SUBDIVISION REPORT - CONCEPT/DEVELOPMENT PLAN

▶ **FILE #:** 5-SB-23-C

▶ **SUBDIVISION:** BRAKEBILL ROAD SUBDIVISION, PHASE 2

▶ **PROPOSED USE:** Attached residential subdivision

SITE PLAN
**BRAKEBILL ROAD SUBDIVISION
 PHASE 2**

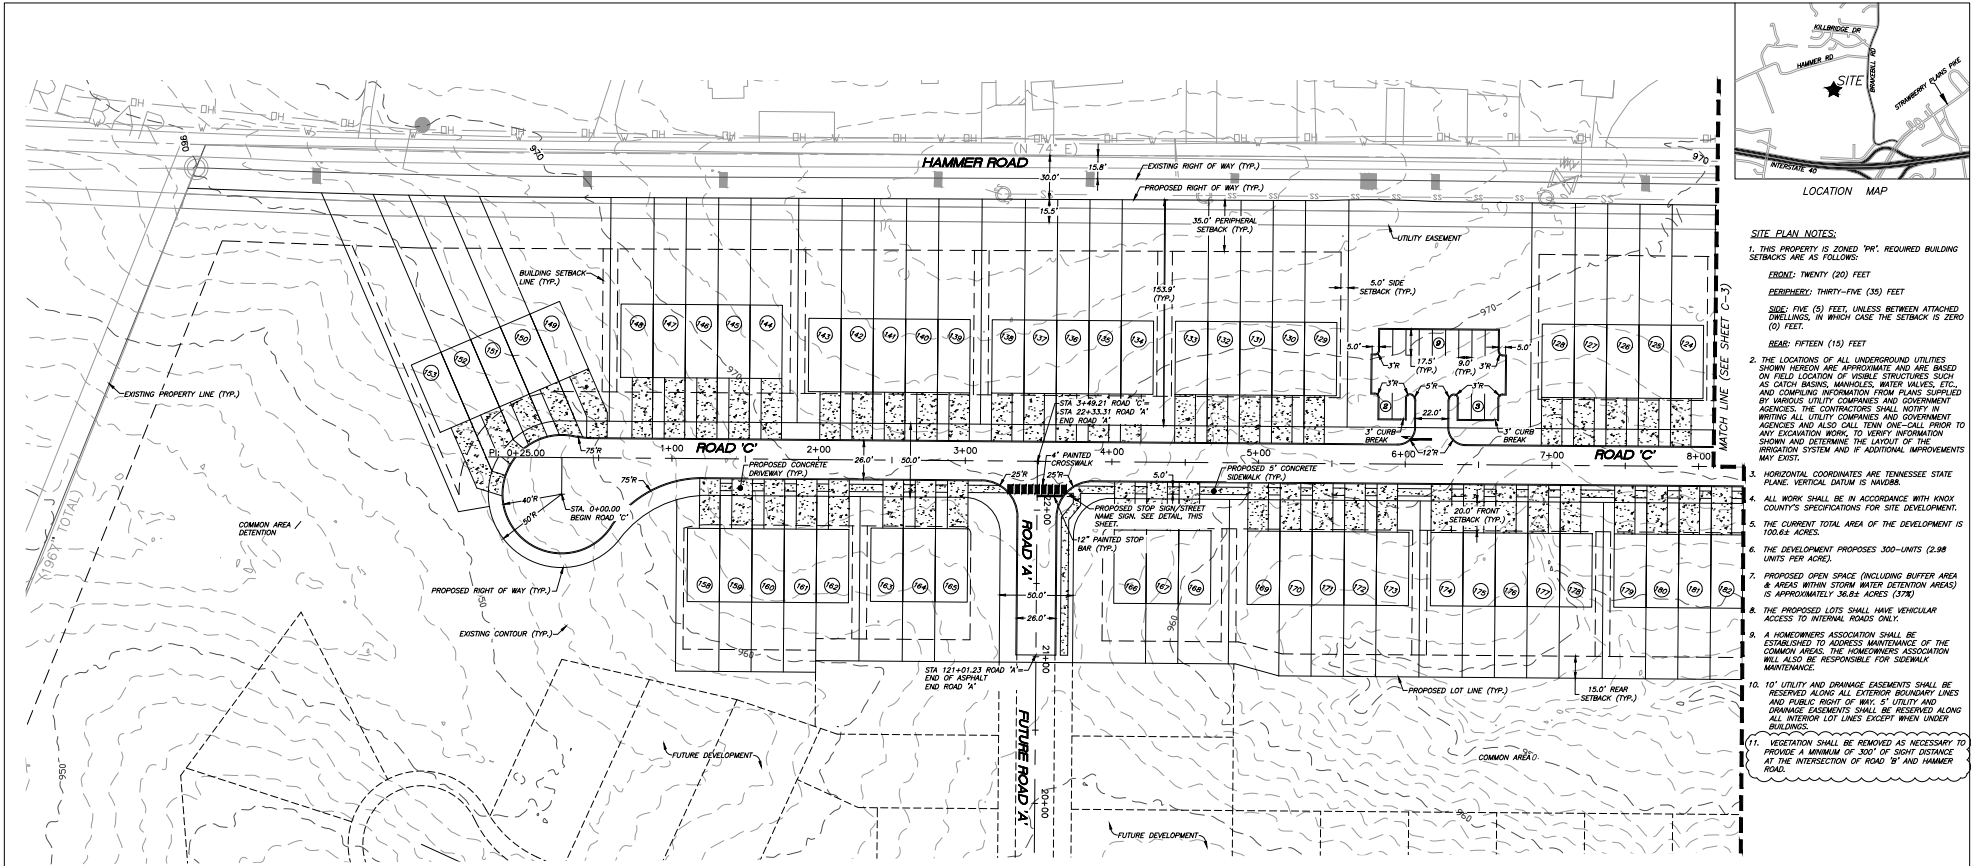
- 1) Meeting all applicable requirements of the Knox County Zoning Ordinance.
- 2) Providing continuous landscape screening along the Hammer Road frontage that is consistent with the intent of the Type B landscape screen (see Exhibit A). The landscape screen may consist of mature existing evergreen and deciduous trees, or newly planted trees. A landscape plan must be approved by Planning staff during the design plan phase. A tree protection plan must be provided for trees that will be maintained.
- 3) The maximum height of the attached dwellings shall be 35 feet.

Staff is recommending that landscape screening be provided along the Hammer Road frontage. This was not a requirement of the 2020 concept plan because this location had detached residential lots. The landscape screening can consist of existing and new trees. A landscape plan must be approved by Planning staff during the design plan phase.

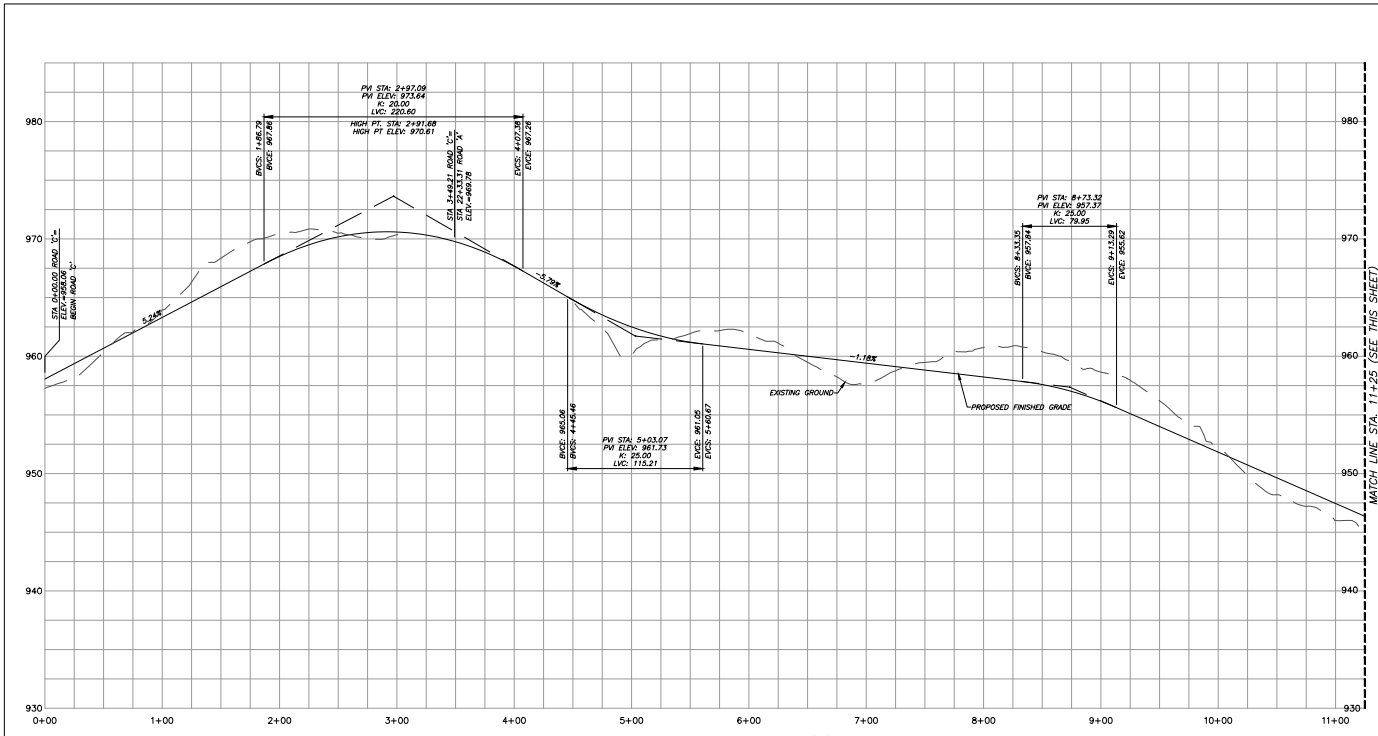
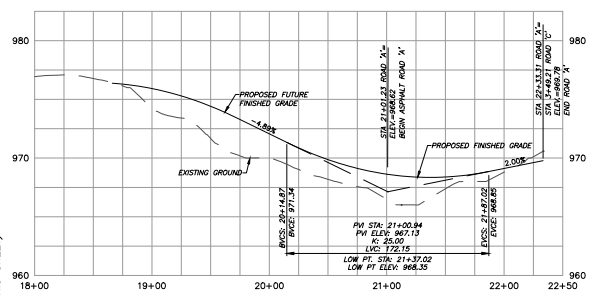
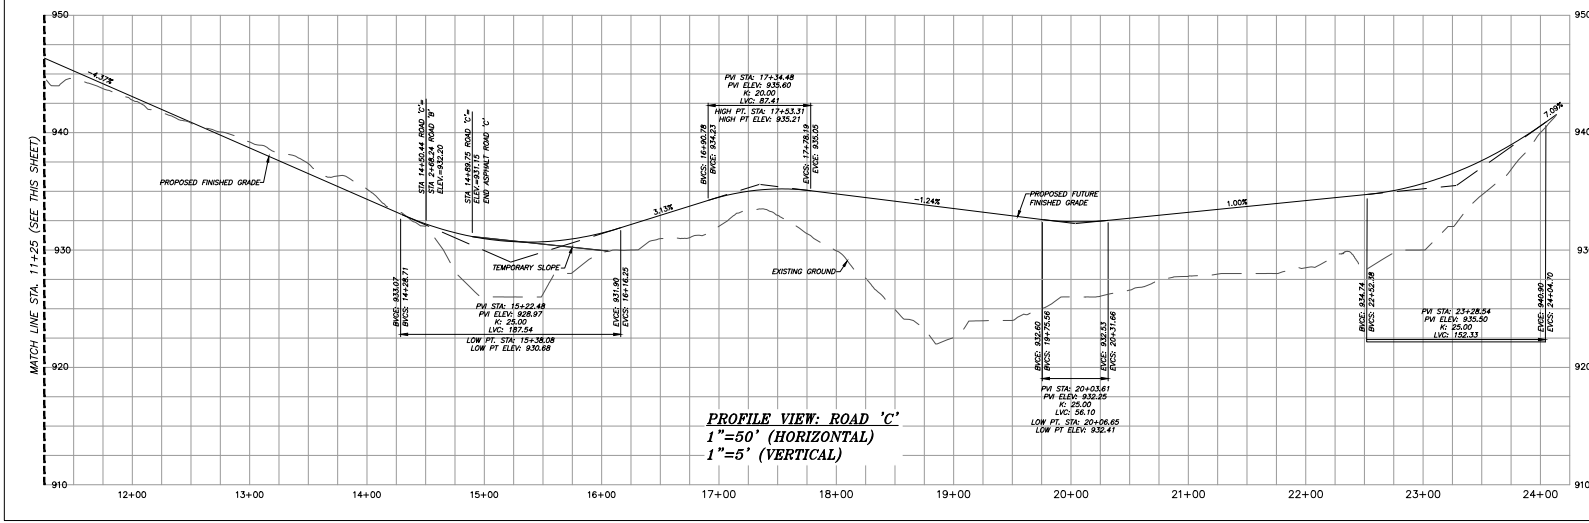
1. Reduce the minimum vertical curve from K=25 to K=20 at the Road 'C' between STA 1+86.79 and 4+07.38
2. Reduce the minimum tangent distance between broken back curves from 150 ft to 118.24 ft on Road 'C' between STA 12+50.70 and 13+68.94

Approve as requested since no unsafe conditions are created.
